Access Compliance Report Public Rights-of-Way (Curb Ramps)

Main Street: HARCOURT_AVE		Cross Street: PACIFIC_PL		Location:	SW
ADA ID: RPAT211123142346	Ramp Type: Type 4 - Parallel	Initial Pass/Fail: Pass	Overall Compliance: No	Severity Score:	5
Codes/Mitigation Info/Possible Solution			Field Measurements/Component Compliance

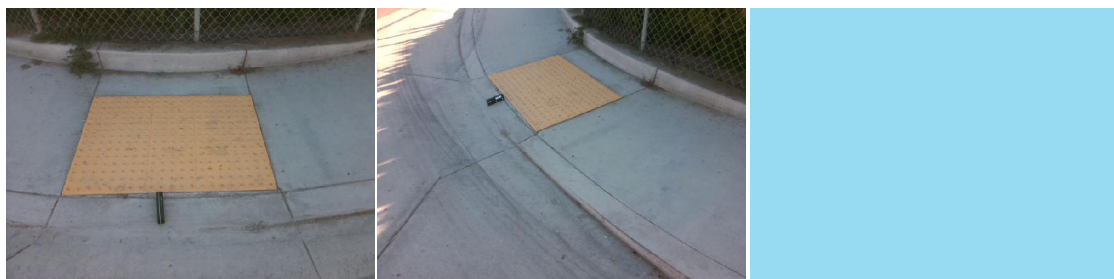
Crossing 1 Slope (%)	1.5		Crossing 2 Slope (%)	4.4
	Crossing 1 Cross Slope (%)	2.9		Crossing 2 Cross Slope (%)	0.2
Yes	Gutter Ponding	No	Yes	Curb Slope	5.6
Yes	Gutter Lip Height (in)	0		Road Run Slope (%)	1
No	Gutter Run Slope (%)	7.1		Road Cross Slope (%)	0.7
Yes	Gutter Cross Slope (%)	1.8	Yes	Perpendicular Joint Present	Yes
Yes	Overall Surface Condition	Acceptable			
	Cross Gutter Present?	Yes		Spandrel Present?	Yes
	Replace Cross Gutter?	No		Replace Spandrel?	No

Remove & Replace Gutter.

R304.5.4, STD 1115
